SI M11 05 13 Engine October 2013 Technical Service

Service Action: N14 Engine Retrofit Turbocharger Engine Oil Supply Line Heat Shield

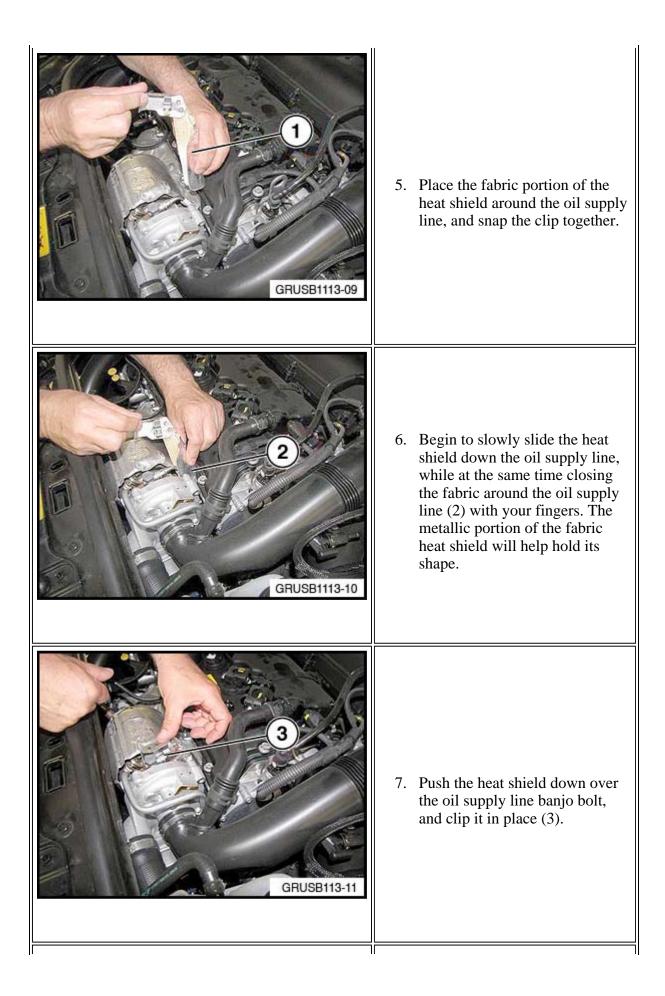
1. Open the engine compartment to inspect the oil supply line. The vehicle may already be fitted with a smaller heat shield that will need to be removed. Proceed to step 2.

Image: Constraint of the second sec	 Example: The oil supply line is not fitted with a heat shield (1).
the second secon	 Example: The oil supply line is fitted with a small heat shield (1). Remove this heat shield and discard it.
O CRUSB113-16	 4. Install the new heat shield with the additional fabric insulation (1) onto the oil supply line (2).

CRUSB113-13	8. Gently use your fingers to adjust the position of the fabric insulation so that it wraps around the oil supply line. Adjusting the fabric insulation will provide maximum protection from heat transfer.
-------------	---
